Arrival Fashion Limited (Extension)

28 April 2024

Production Building 2: This is a six-storied (B+G+5) reinforced concrete (RC) building with a basement.

Observation-1: Inconsistencies in design documents. (Production Building 2)

Adjacent external steel stair

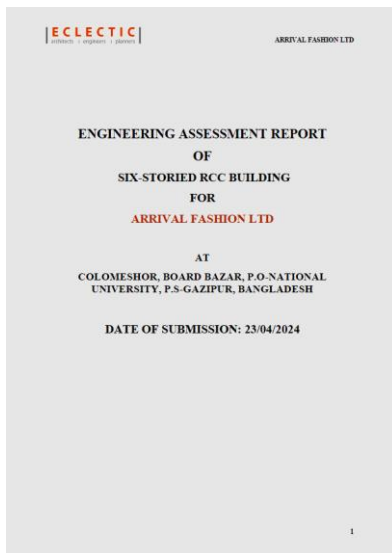
Connection with the main building

Description: The adequacy of the Mat foundation and slabs was not incorporated in the provided engineering assessment (EA) report. Also, an adjacent external steel stair connects with the main building. However, no evaluation of steel stair was provided in the engineering assessment.
